# SERVICE INSTRUCTION

## ROUTINE MODIFICATIONS

### OF THE BING CONSTANT DEPRESSION CARBURETOR

SI-912-012 R1  
SI-914-014 R1

(see fig. 1 and fig. 2)

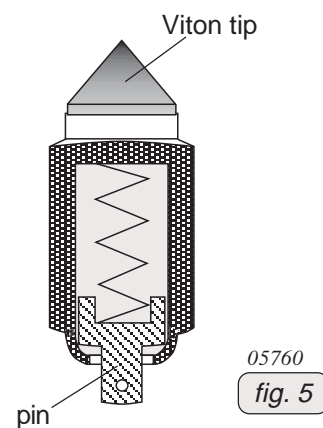
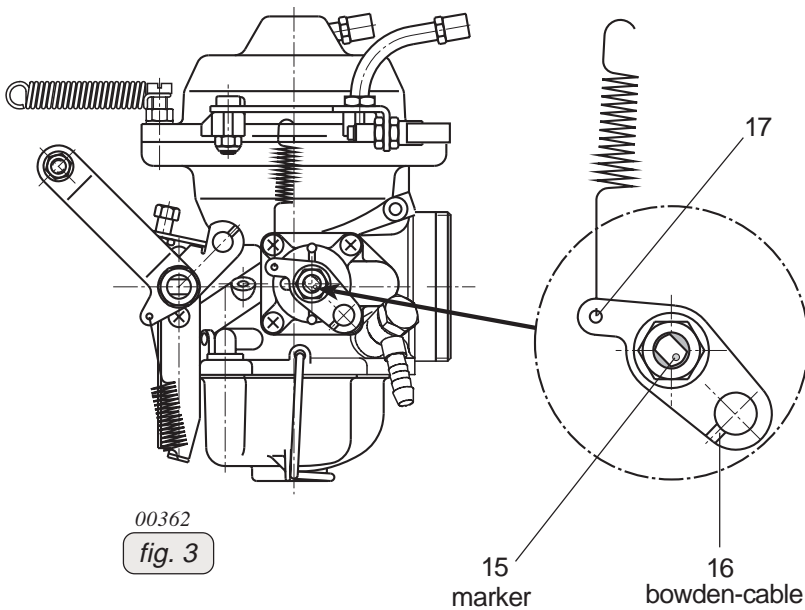
Damping of the jet needle has been standardized through the additional O-ring (1) part no. 950430 and fixation screw (2) part no. 961292 as already known from the ROTAX® 912 S/ULS/ULSFR.

◆ **NOTE:** This O-ring can be used for older carburetors only in combination with fixation screw (2) part no. 961292 since a recess is required for the additional O-ring in the fixation screw. This also applies to spare parts.

Apply screw securing agent TufLok onto fuel line connector (3) part no. 941853 as has been done for the fixation screw. Depending on engine type, order the appropriate fuel line when procuring spare parts.

The material of choke housing gasket (4) was changed with the part no. 950030 retained and is now black instead of red previously.

A further change of material was introduced on the gasket under the chamber top (14) part no. 961250 blinding shim.

The spring retainer has been improved for throttle lever (8) and cable support (9). Sleeve (11) and (10) was introduced. The part no. of the new throttle valve lever assy. is 963020 for carb. 2/4 and 963025 for carb. 1/3. The part no. of the new cable support assy. is 961267 for carb. 2/4 and 961262 for carb. 1/3.

Replacing the sealing ring, an O-ring (12) part no. 631770 including changed attachment screw (13) (attachment screw assy. part no. 963281) has been introduced.

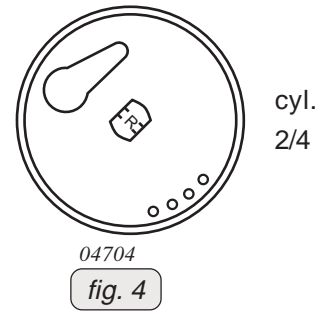
■ CAUTION: The choke shaft has a marking point (15) (see fig. 2 and fig. 3). This marking needs to point towards the bowden-cable fitting (16) in order to function correctly.

However carburetors with the following serial number have their marking pointing towards the spring retainer (17). When performing maintenance work, remove this marking point and remark correctly.

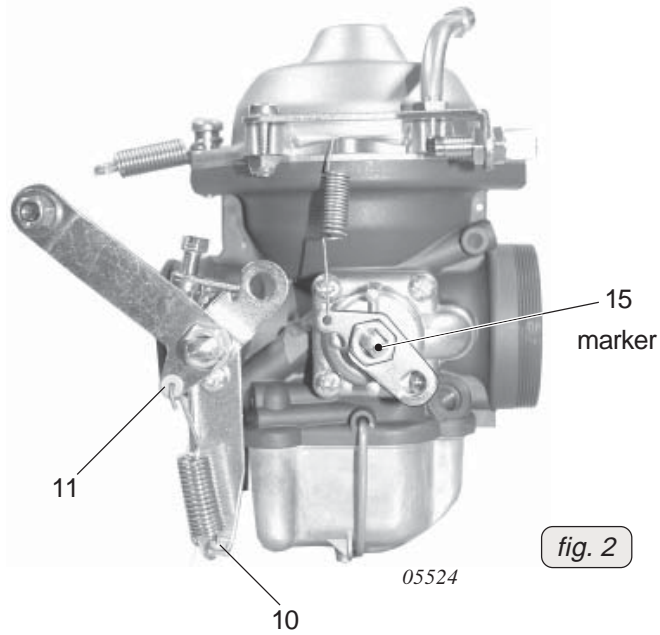
◆ NOTE: The rotary disc valve has L and R markings. The shaft marked with L is meant for the carburetor for cylinder 1/3, and the R marking is meant for the carburetor for cylinder 2/4. Fig. 4 represents the marking positions on the inside choke shaft.

■ CAUTION: The choke device will not function with the choke housing mixed up.
